CITY OF MERCER ISLAND

STAFF REPORT

DESIGN COMMISSION DESIGN REVIEW

Project No:	DSR19-017
Description:	Upgrades to North Mercer Pump Station (NMPS), including: <ol style="list-style-type: none">1. Upgrade and expansion of existing building;2. Construction of a new building and concrete pad to house standby generator and fuel tank;3. Installation a new restroom and odor control fan; and4. Construction of a temporary pump station to manage flows during construction.
Applicant/ Owner:	King County Wastewater Treatment Division
Site Address:	7631 SE 22nd St (Parcel Number 531510-1946)
Zoning District	R-8.4
Staff Contact:	Robin Proebsting, Senior Planner
Exhibits:	<ol style="list-style-type: none">1. Application2. Plan set for North Mercer Pump Station (NMPS) Upgrade prepared by Tetra Tech and Jacobs, dated December 20193. Notice of Application, dated December 30, 20194. Notice of Public Hearing, dated September 28, 20205. Determination of Nonsignificance issued by Jim Sussex, King County Wastewater Treatment Division Water Quality Planner, dated May 23, 20196. SEPA Checklist prepared by Katherine Fischer, King County Wastewater Treatment Division Environmental Programs Managing Superv

DCN:	DATE: 05/02/2019
PROJECT FILE NO:	
DRAWING NO: C141	
SHT NO / TOTAL: XXX /	REV NO:

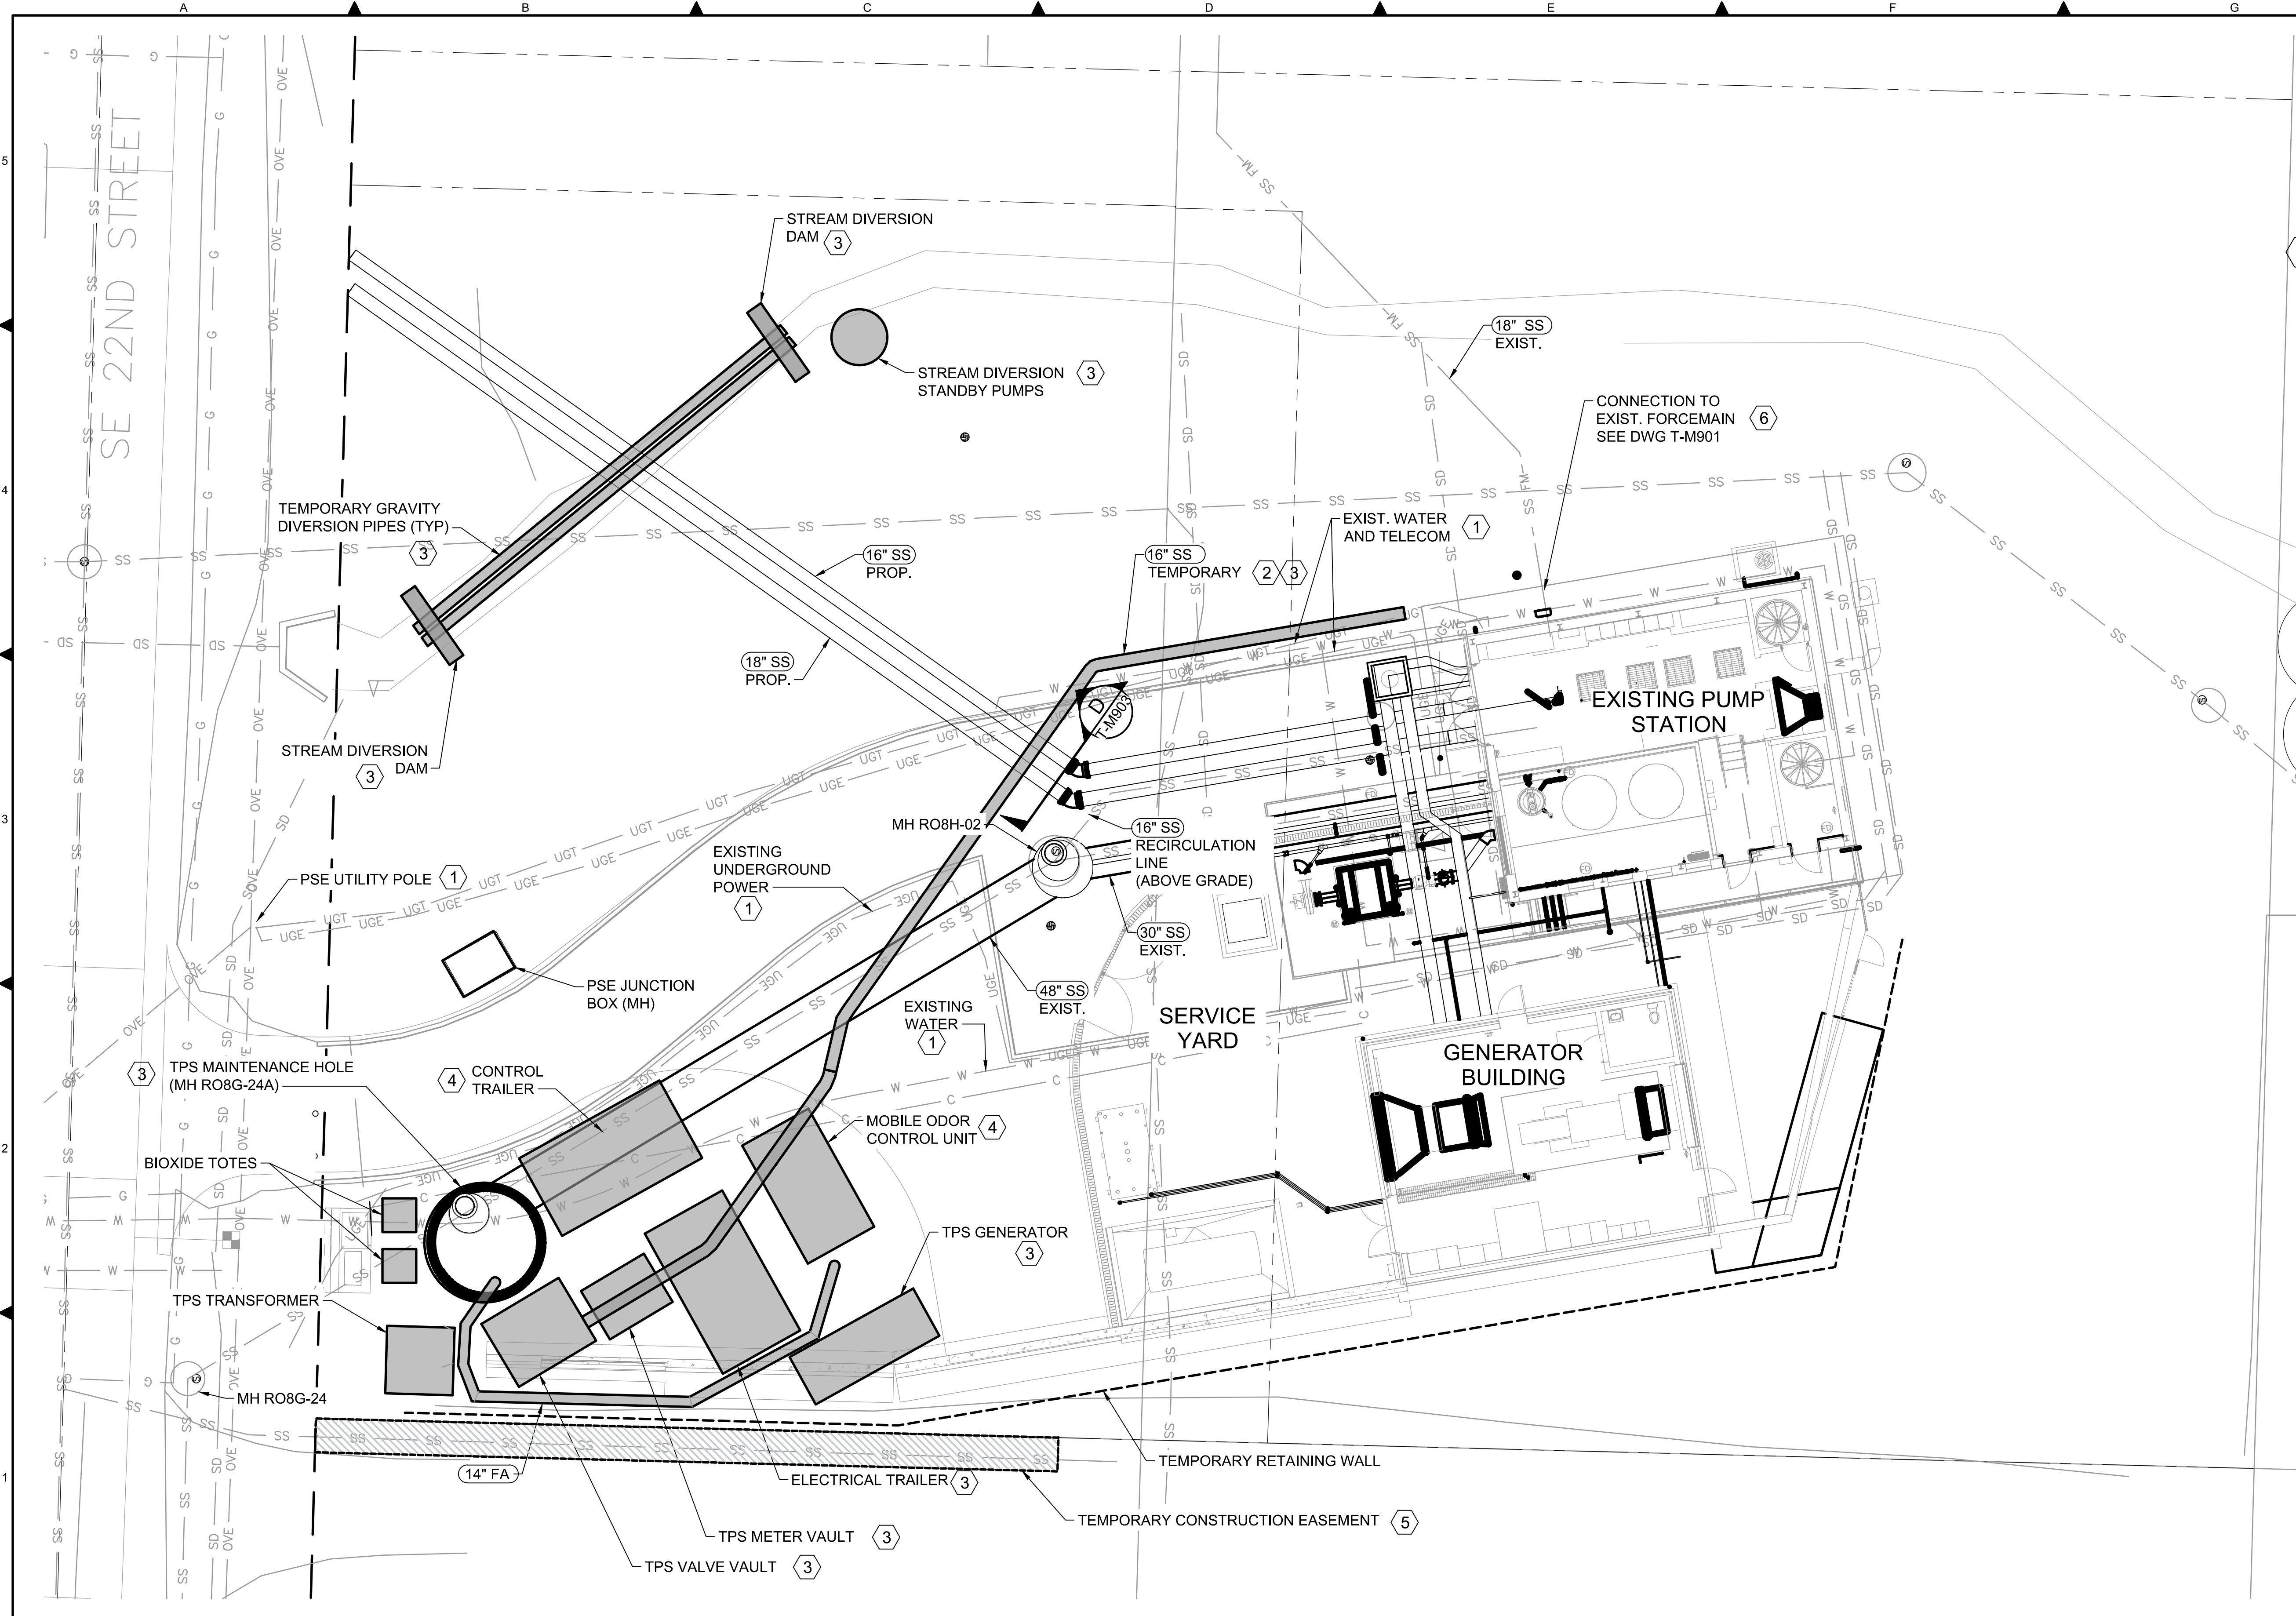
Staff Analysis: Small areas of grading are proposed to accommodate the new generator building and turnaround; resulting graded areas will be approximately 20%, which is less than a 4(H):1(V) slope (Exhibit 2, Sheet C141). Temporary erosion control measures, including silt fencing on the downslope side of the proposed clearing limits, inlet protection around drainage systems, and sediment traps are proposed during construction (Exhibit 2, sheet C101). The site is proposed to be fully landscaped outside of buildings and paved surfaces (Exhibit 2, sheet L101).

DCN:	DATE: 12/16/2019
PROJECT FILE NO:	
DRAWING NO: A206a	
SHT NO. / TOTAL	REV NO.

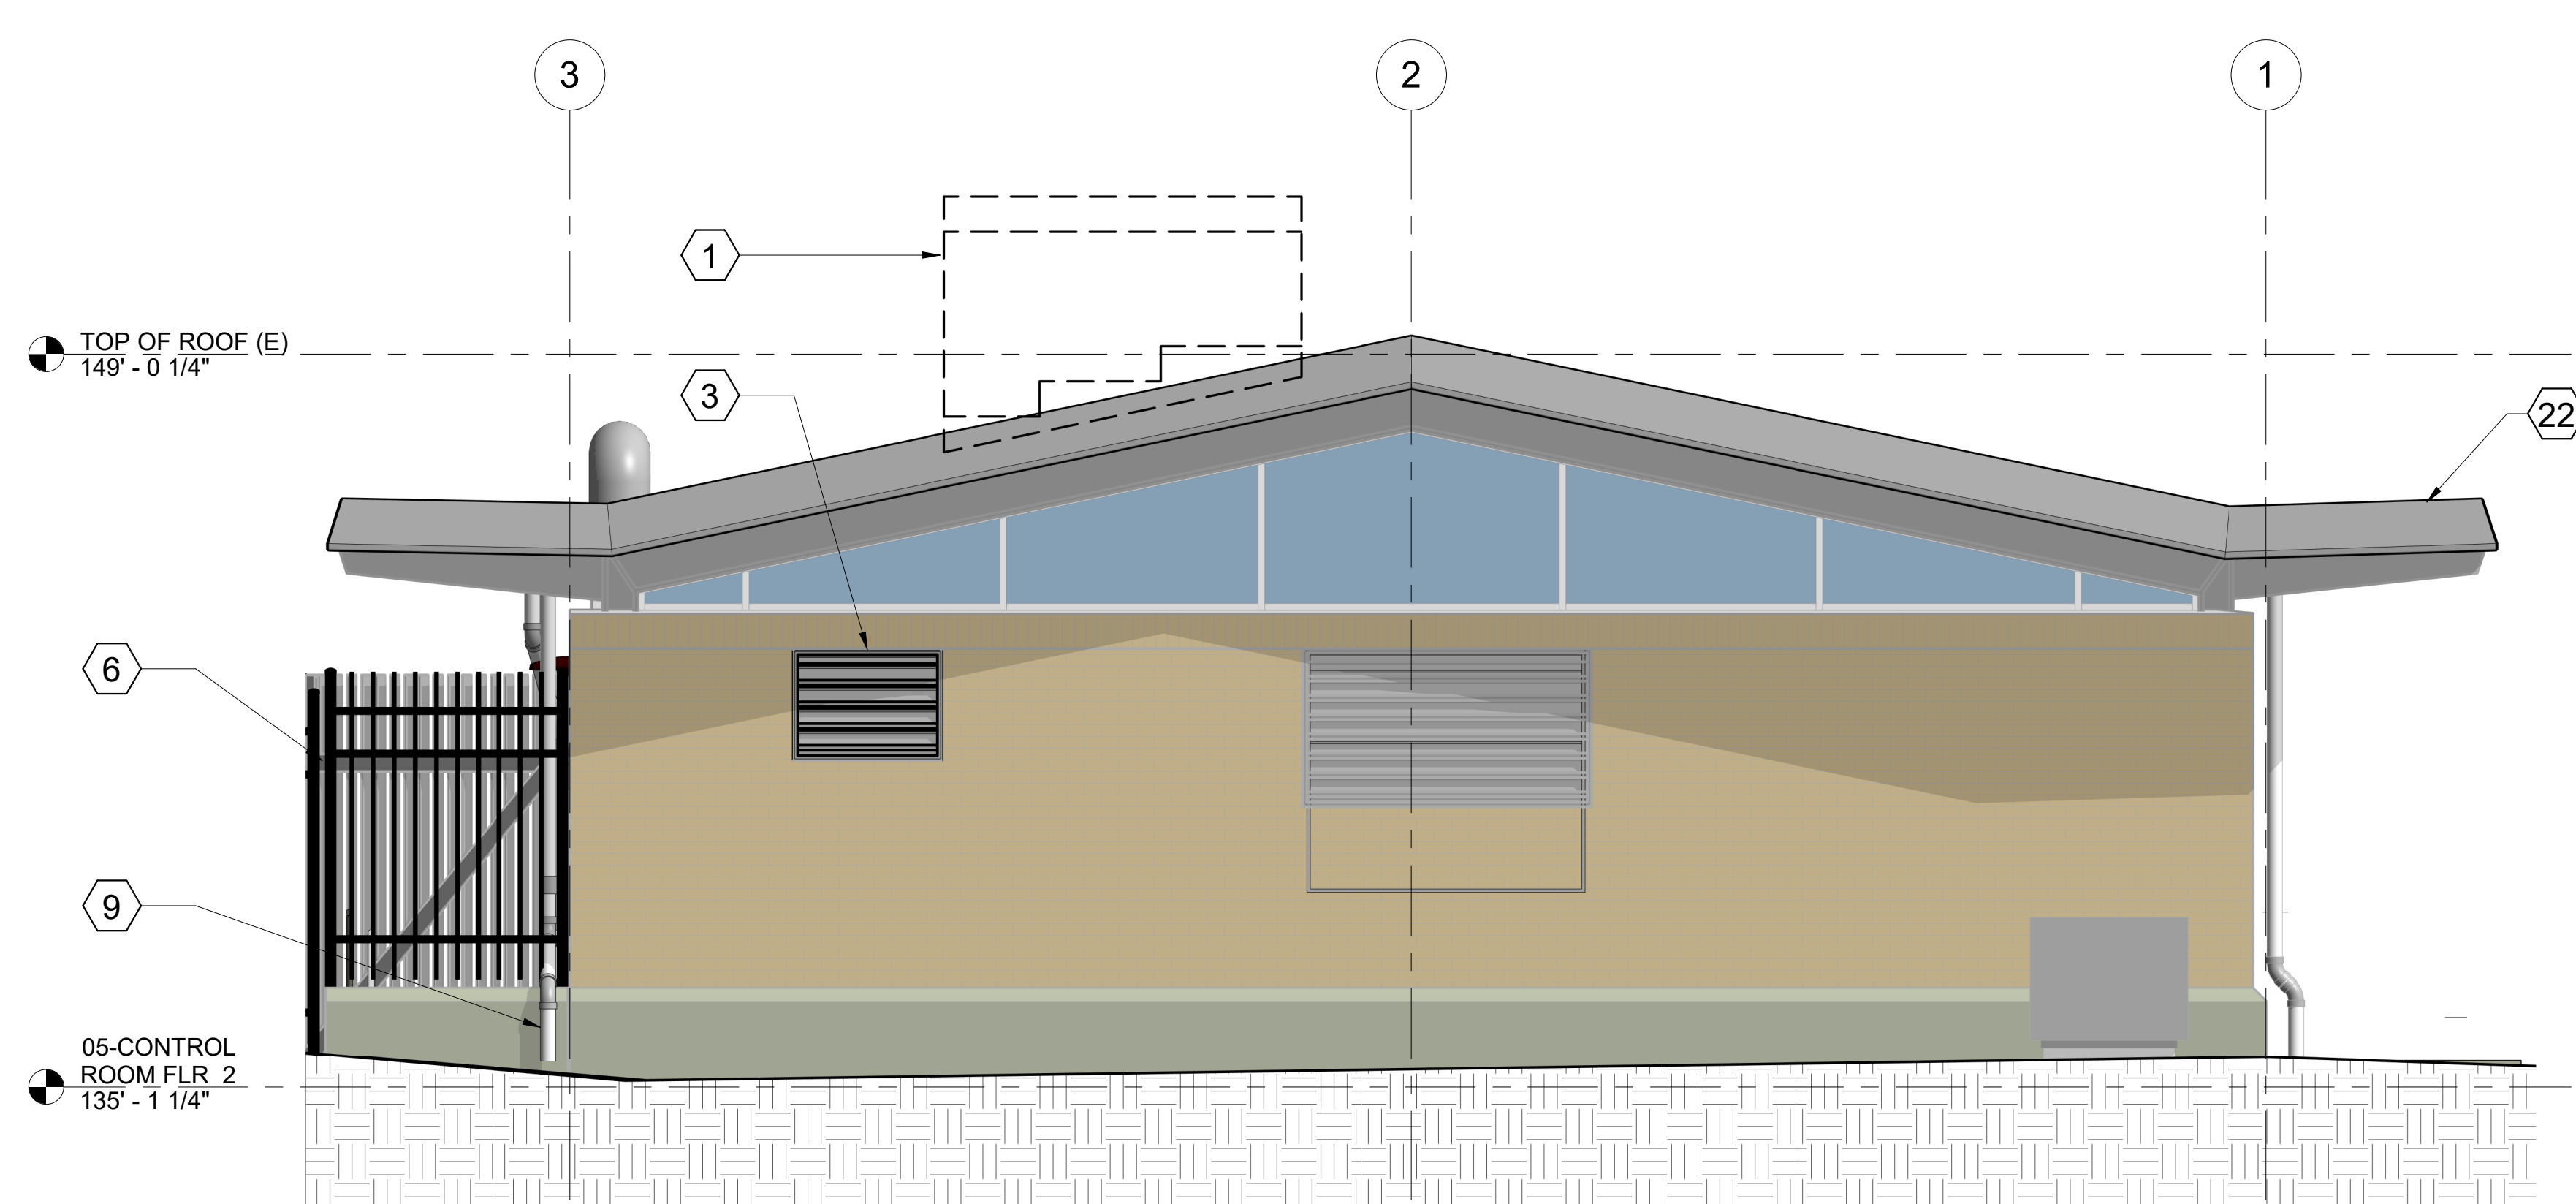
Courtyard fencing and modulation in materials along the front façade provide for vertical and horizontal modulation on the buildings. Horizontal modulation occurs at a maximum of 18 feet, consistent with this standard. The proposed generator building façade is not stepped back, but the proposed design meets the objectives in MICC 19.12.030(A) by using a coherent design that is consistent with the style and materials utilized in the neighboring pump station building (Exhibit 2, Site Photos, Sheets 206a, 207a, 208a, and 209a).
